**RE: Custom Home**  
**2216 Ana Ct NW**  
**Grading and Drainage Plan**  
**Engineer's Stamp Date: 12/08/25**  
**Hydrology File: H11D012A**  
**Case # HYDR-2025-00462**

Based upon the information provided in your submittal received 12/30/2025, the Grading & Drainage Plans **are not approved** for Grading Permit or Building Permit. The following comments need to be addressed for the approval of the above referenced project.

## GRADING & DRAINAGE PLAN

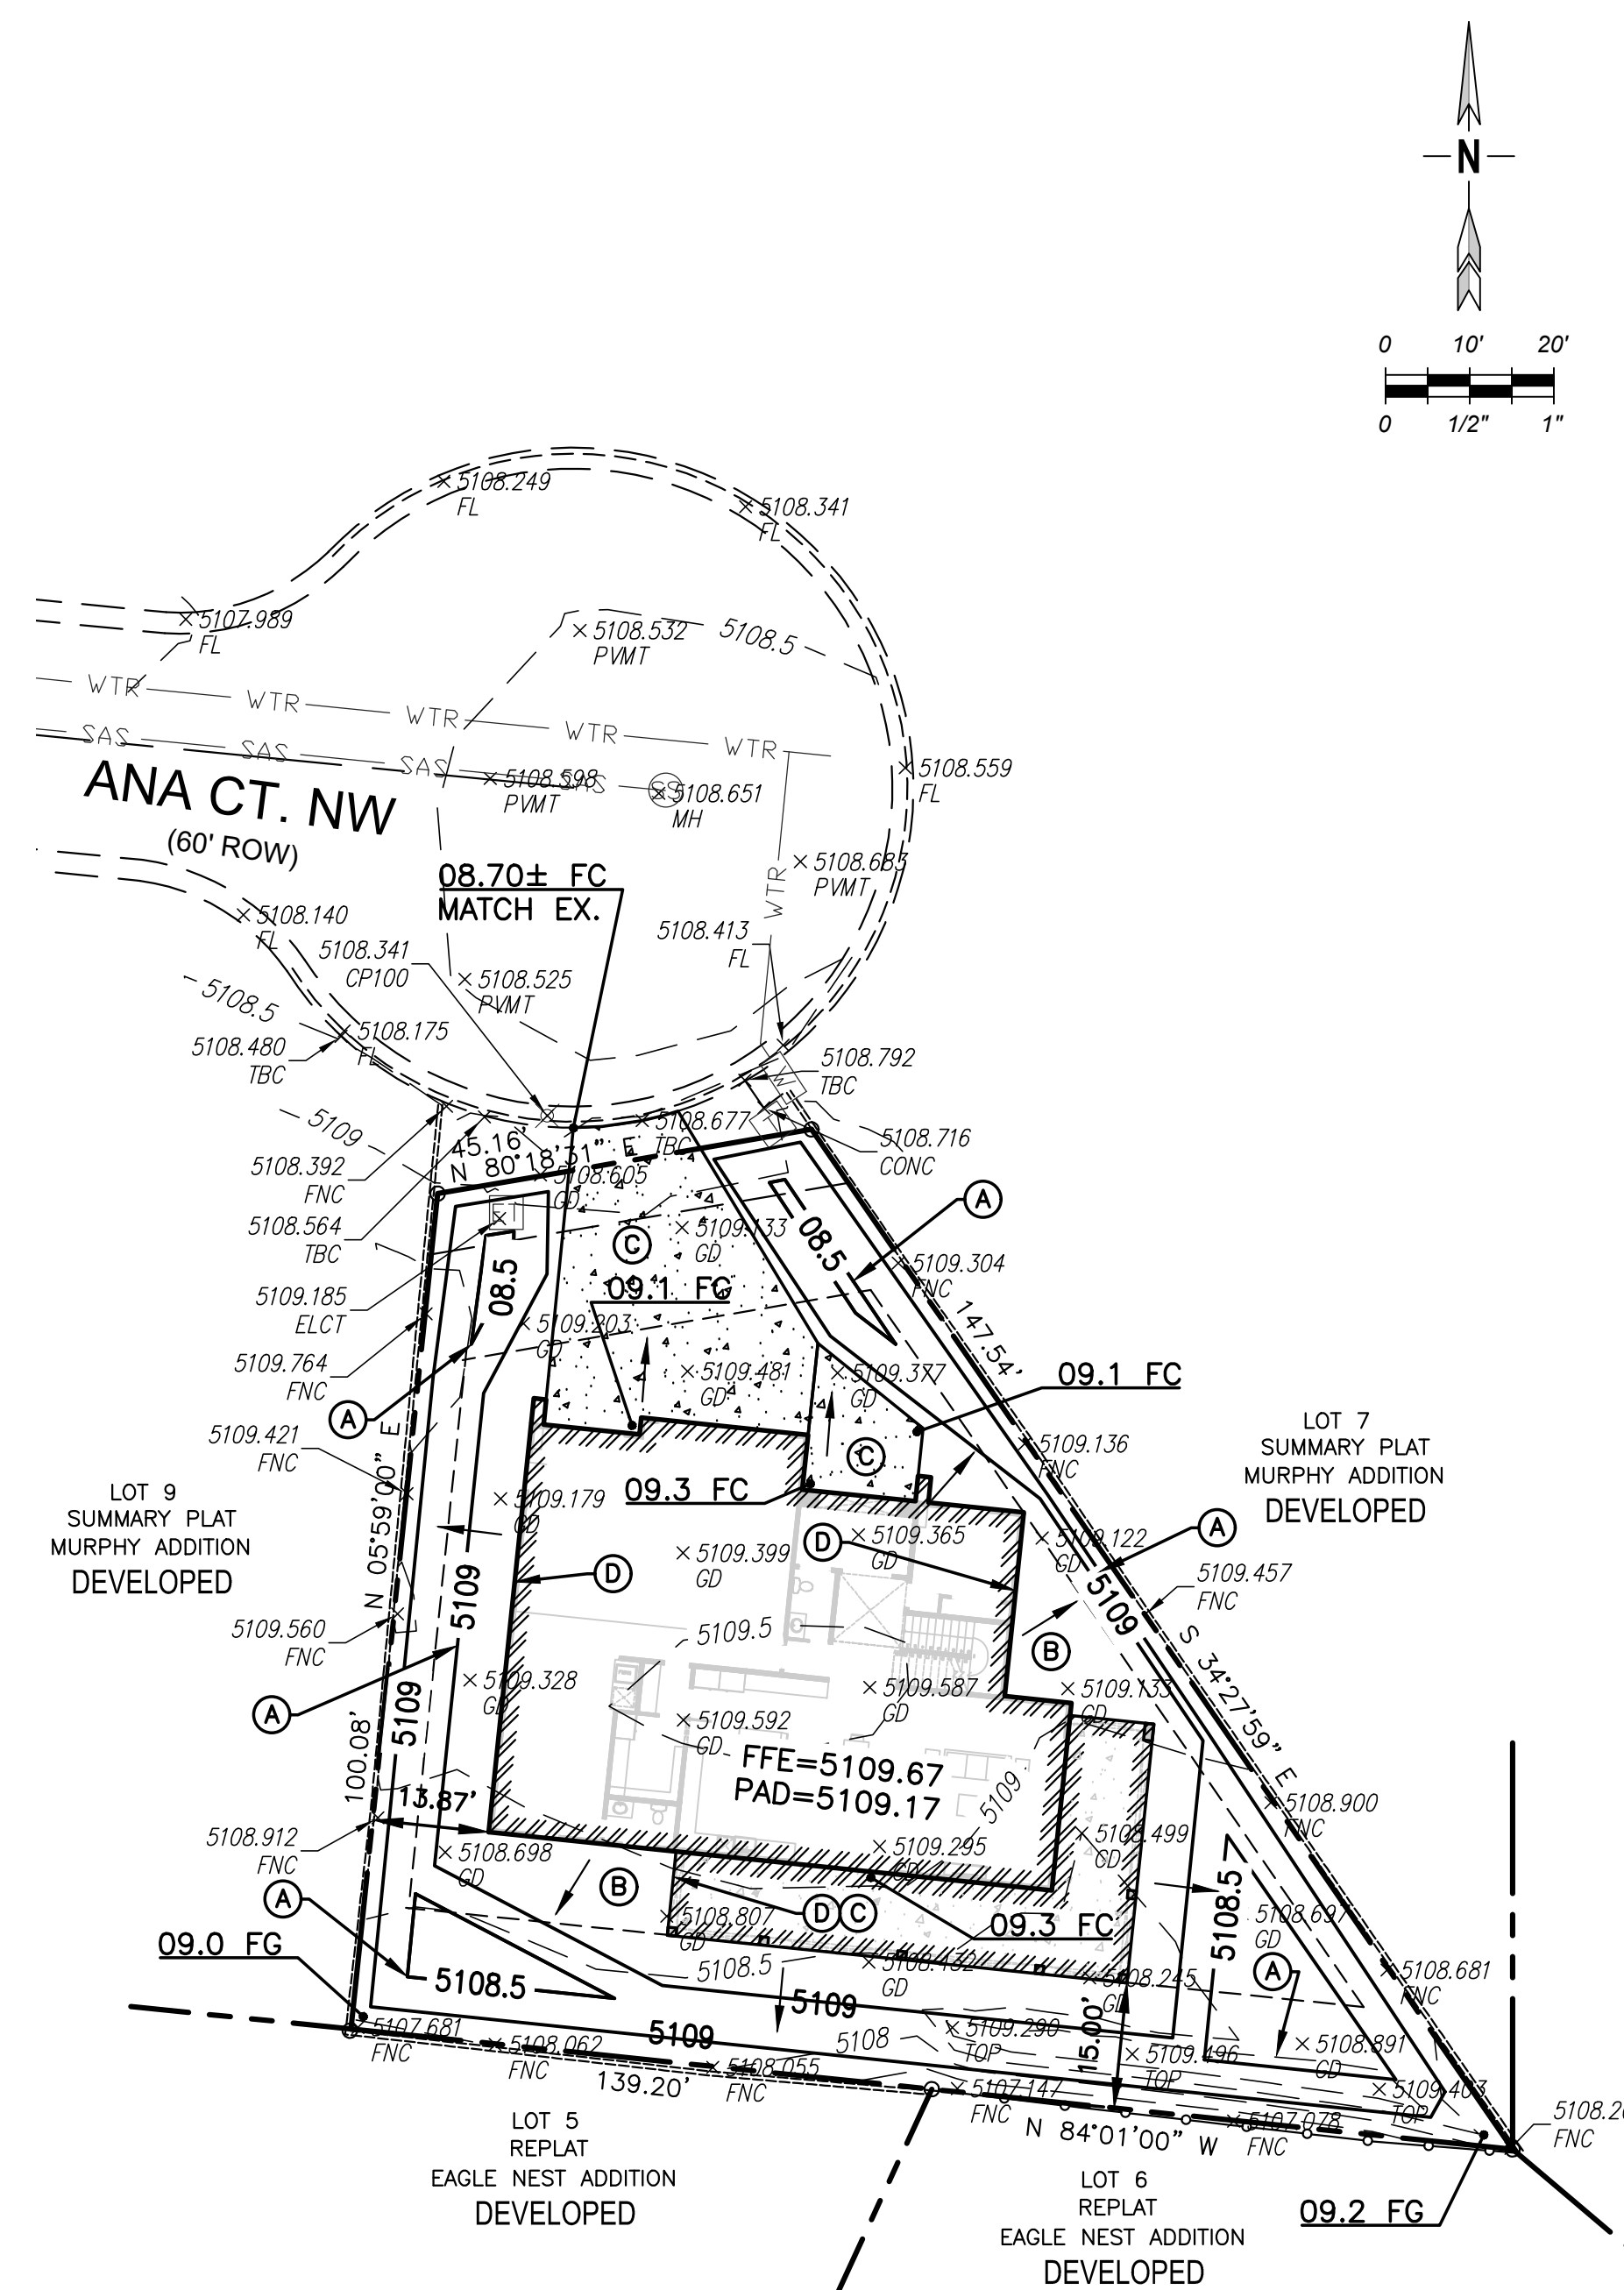
1. Per the IDO, the property owner of the property is responsible for building the adjacent half of Ana Court NW to include curb & gutter, **and sidewalk**. The project will have to go to the Development Facilitation Team (DFT) for approval of the Infrastructure List. Please show the sidewalk on the plan.
2. The SE corner of the site has an existing wood fence that will not control stormwater from crossing the property line. Please show a block wall to contain the stormwater to the site.

3. Provide the existing and proposed grades on both sides of any existing and proposed walls.
4. Provide sections through all external boundaries showing proposed retaining walls, garden walls, property/ROW lines, existing and proposed grades. In accordance with DPM Ch.22, section 5 part B, grading and wall construction near the property line may not endanger adjacent property or constrain its use
